MassDOT ROW would like to thank all the consultants for taking time to participate in the survey questionnaire about the Plan Preparation Guidelines for Consultants Preparing ROW Plans, and the subsequent ACEC/MA session. We are excited to incorporate the feedback received into the next issued set of guidelines. We hope that we were able to provide an improved understanding of the ROW process and reinforce the Departments' expected standards. Below responses are provided to the open-ended questions from the survey.

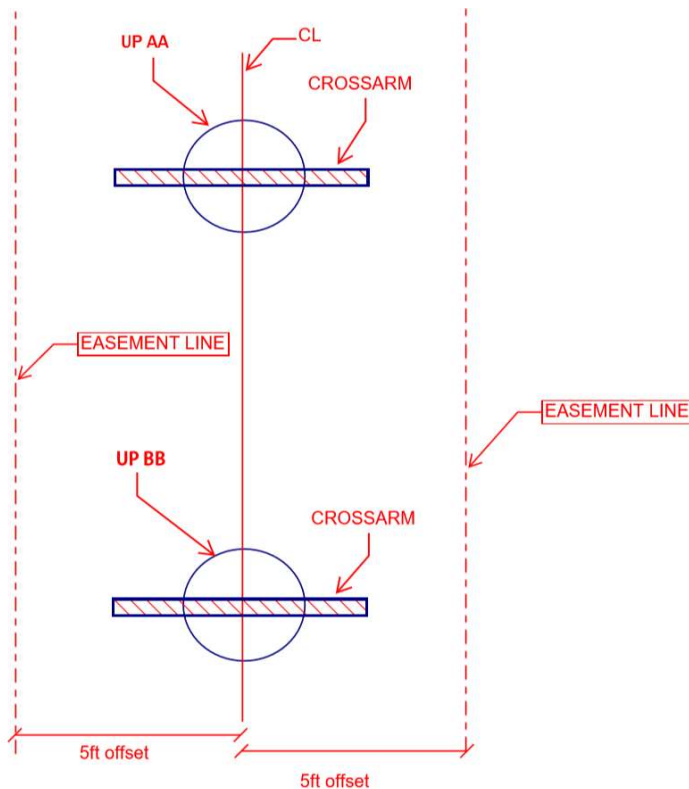
24. In the next issued guidelines, we would like tree trimming limits for overhead wires and PUEs.

If tree trimming is required, we will need that shown on the ROW plans. The PUE will cover the tree trimming inside of the PUE limits. The PUE should be extended enough to accommodate the future maintenance required at the location. If additional tree trimming is required for construction, but does not require future maintenance, then the work should be covered within a TE.

We will add guidance for tree trimming limits in the next issued guidelines.

DETAIL 1:

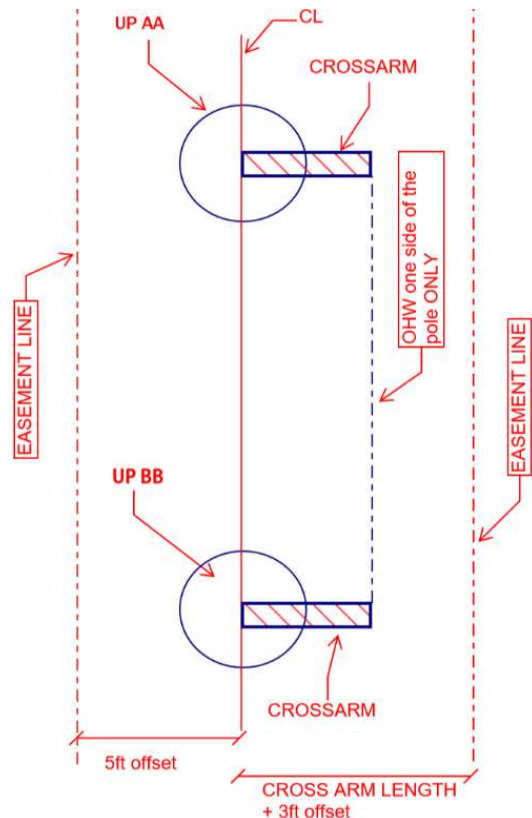
25. In the next issued guidelines, we would like to see dimensions and/or restrictions for overhead wires and guy wires.

PUE’s are 5’ offset and parallel to pole-to-pole center line for cross arm construction

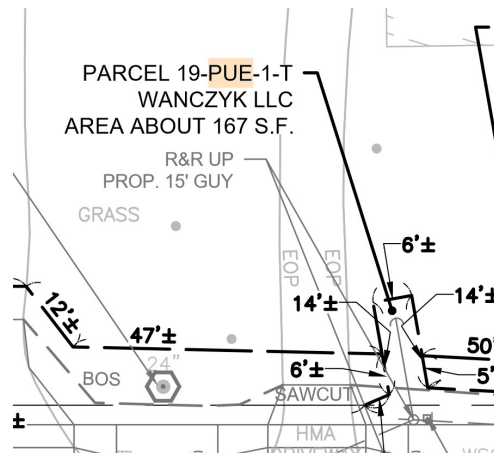
26. Page 42 - Public Utility Easement - could there be a little more explanation of what is meant with the two options mentioned in the first sentence of this paragraph?

For guy wires, the PUE should be 6' wide (3' on each side of the wire).

The PUE shall extend approximately 3' beyond the guy wire anchor. If the guy wire is perpendicular, or nearly perpendicular to the layout/alteration, the PUE should be offset parallel from the layout/alteration.

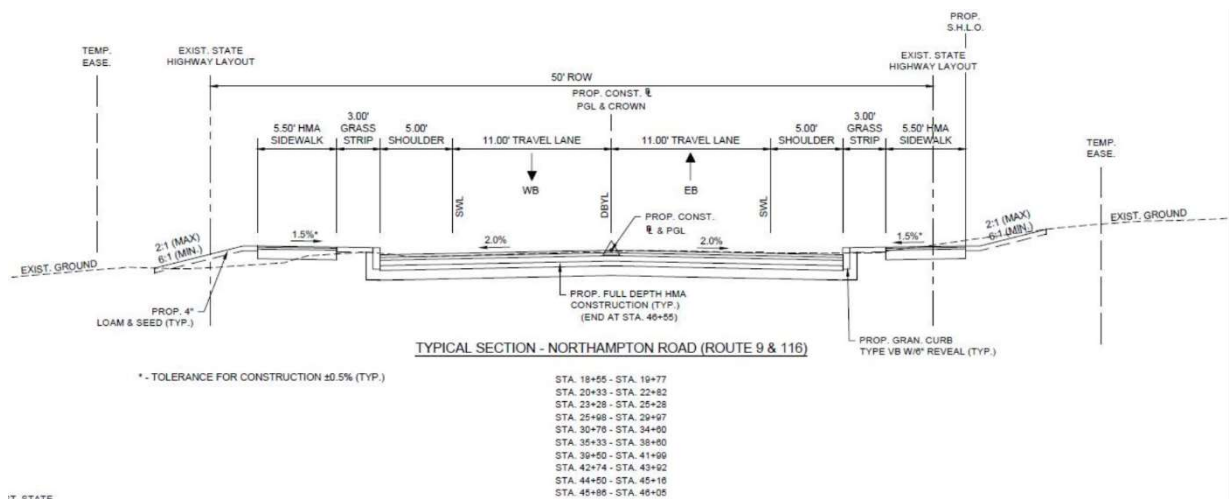
40. Guidance on Page 44 and the Figures on Page 45 seem to indicate that if the proposed improvements are completely contained within an existing ROW that no temporary easement would be necessary/required. In our opinion this is misleading as additional space is often required for construction access which would mandate a temporary easement be obtained in these situations. Please clarify the intent of this section.

Please be aware this section of the guidelines applies to State ROW only. In the designer’s professional opinion, if the contractor can build entirely within the Public LO, a TE should not be provided. If the contractor needs additional space, then a TE should be provided.

For municipal ROW projects, the guidelines specify a minimum of 5’ beyond the limit of grading. Municipal roadways have different physical features than state highways and are typically narrower, so the requirements are different.
